**Cedar Hill Estates  
Preliminary Plat  
Staff Report**

To the  
**Planning Commission  
City of De Soto, Kansas  
November 21, 2006**

| Agenda Item:         | Consider Preliminary Plat for Cedar Hill Estates, 19.5 acres located at the southwest corner of Waverly Road and 89 <sup>th</sup> Street.   |
| Submittal Materials: | Preliminary Plat entitled "Cedar Hill Estates" dated 11/17/06<br>Preliminary Landscaping Plan dated 11/17/06<br>Preliminary Grading Plan (undated)<br>Preliminary Street Profiles (undated)<br>Drainage Study |

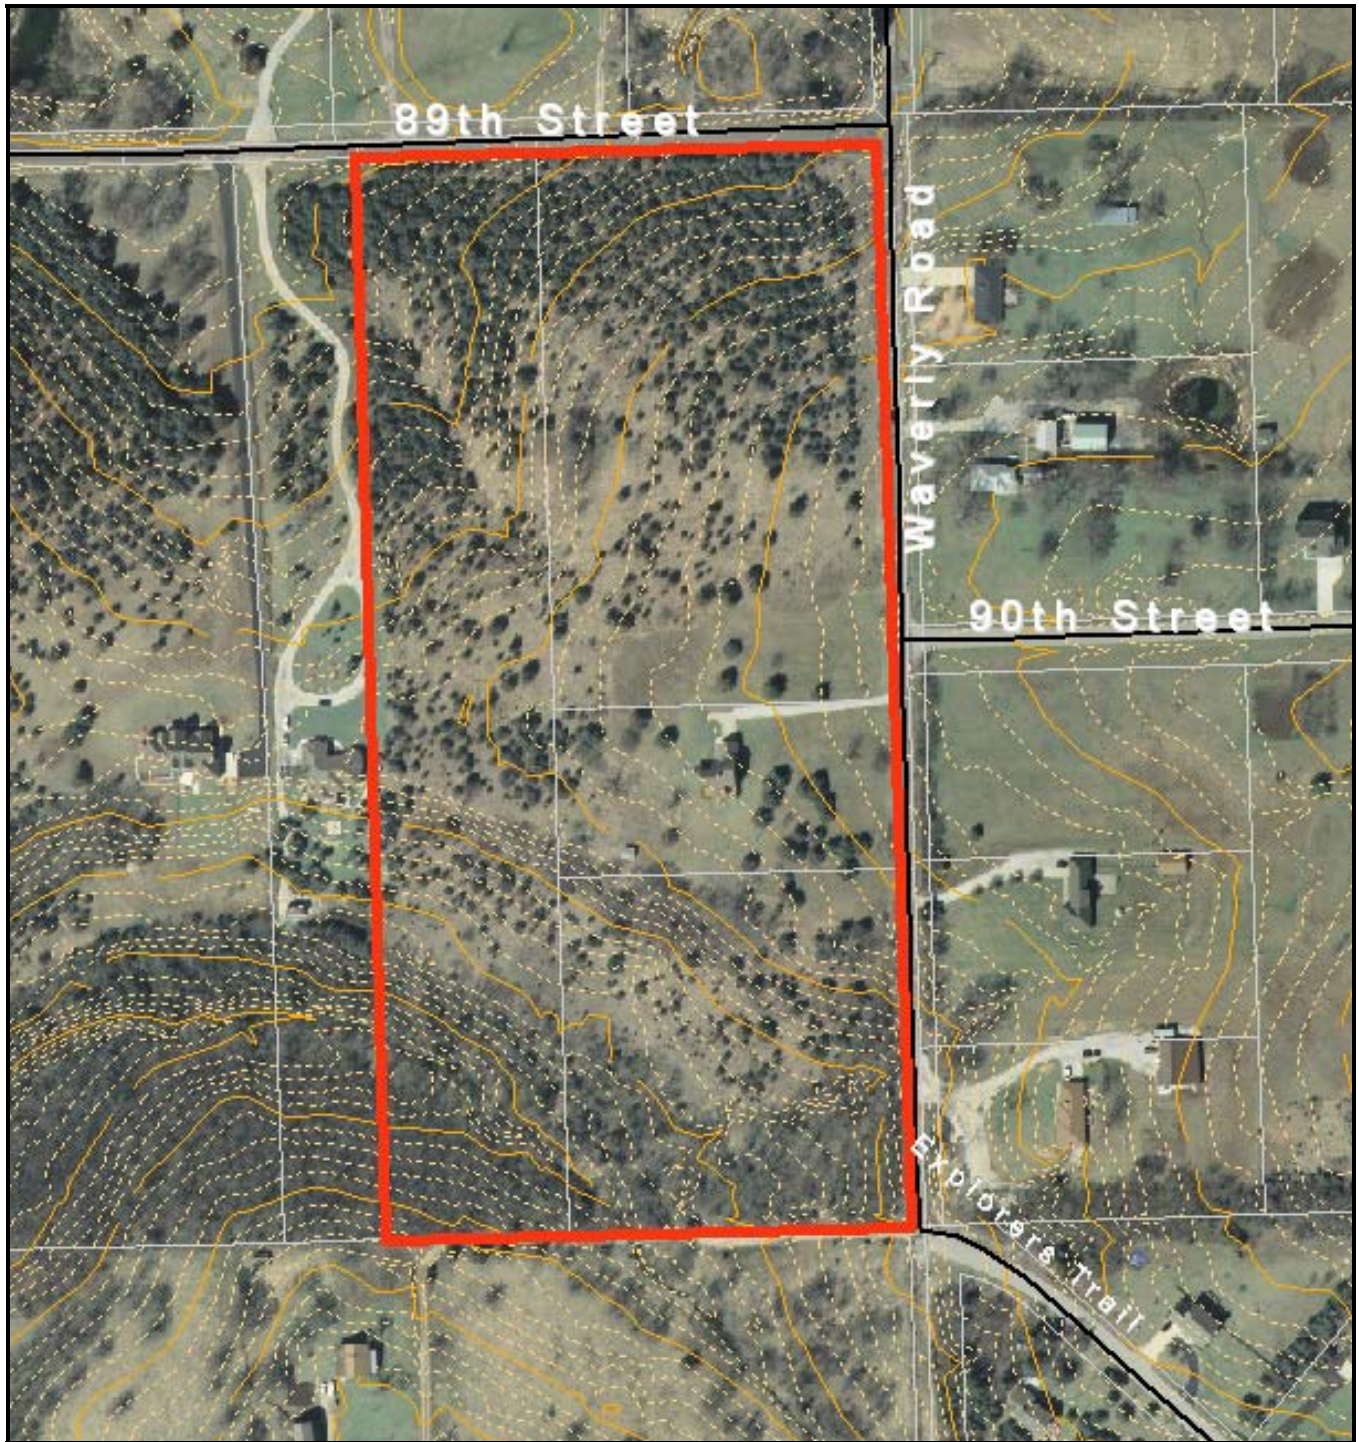
According to the 'R-1' District Regulations contained in Zoning Regulations, the minimum lot area is 10,350 square feet and the minimum lot width is 90 feet measured at the front setback line. The district requirements stipulate a minimum front yard setback of 35 feet. All of the proposed lots meet the district requirements, with the exception of Lot 13, which does not meet the minimum width requirement measured at the front setback line. Lot 13 should be revised to have a 90-foot width at the front setback line.

- a) The plat indicates 40 feet of total existing right-of-way for 89<sup>th</sup> Street. The Comprehensive Plan designates 89<sup>th</sup> as a collector road. As such, 60 feet of right-of-way is recommended. The plat should therefore indicate an additional 10 feet of right-of-way dedication along the north lines of Lots 1 through 4. Doing this will cause Lots 1 through 4 to fall below the 1.00 acres required for on-site septic systems.

- b) The preliminary plat application indicates the road width of 24 feet, and right-of-way widths of 50 feet. The width roadway width is required to be 28 feet, measured from the back of curb to the back of curb. The plat should be revised to show 28-foot roadway widths.

- c) Curb radii are required where the cul-de-sac bulbs intersect the typical roadway section. This should be shown on the plat. In addition, the right-of-way lines should have radii at these locations to make room for utilities around the cul-de-sacs. This may take lot area away from Lots 6 and 10, causing them to drop below the 1.00 acres required for septic systems.

- (1) The study reports that there are 50 acres of land that drain onto the site via the drainage channel at the southwest corner. The drainage area map provided does not include the tributary acreage south of K-10. Staff estimates that there is approximately 40 acres of land south of K-10 that drains onto this site. This will drastically impact all the calculations associated with the proposed detention facility, and the needed easements associated with the channel.

- (2) The contours shown on the preliminary plat and in the drainage study do not appear to be the latest data available from the Johnson County AIMS department (See the Physical Features Map in this report). This could dramatically impact the detention storage volumes and how the pond functions.

(4) The total volume indicated for the proposed detention facility is 121,474 cubic feet. Based on the preliminary grading plan, I estimate the volume to be only about 75,000 cubic feet.

(6) The City's stormwater specifications, (Section 5600 of the APWA requirements), call for the preservation of all streams with tributary areas larger than 40 acres. A stream buffer is required. The buffer must be 60 foot in width measured from the ordinary high water mark, in each direction of the stream. This buffer should be shown on the plat as an easement that restricts disturbance activities.

(7) There is a 24" culvert running under Waverly Road adjacent to Lot 15 that carries flow from approximately 10 acres. This flow travels across Lot 15 and into the larger channel along Lot 14. The plat should indicate a drainage easement for this channel, or it should indicate provisions to re-route this flow. The existence of this drainage easement may make the installation of a septic system unfeasible on Lot 15.

The plat indicates a new 6-inch water mains along the two proposed cul-de-sacs. There are no fire hydrants shown. The plan should indicate the location of proposed hydrants.

around the parameter of the subdivision parcels, there are no easements shown along the proposed rights-of-way. 10-foot utility easements should be added along all proposed streets.

a) The preliminary plat document indicates 5-foot concrete sidewalks, although the grading plan shows 4-foot walks. The grading plan should be revised to show 5-foot walks.
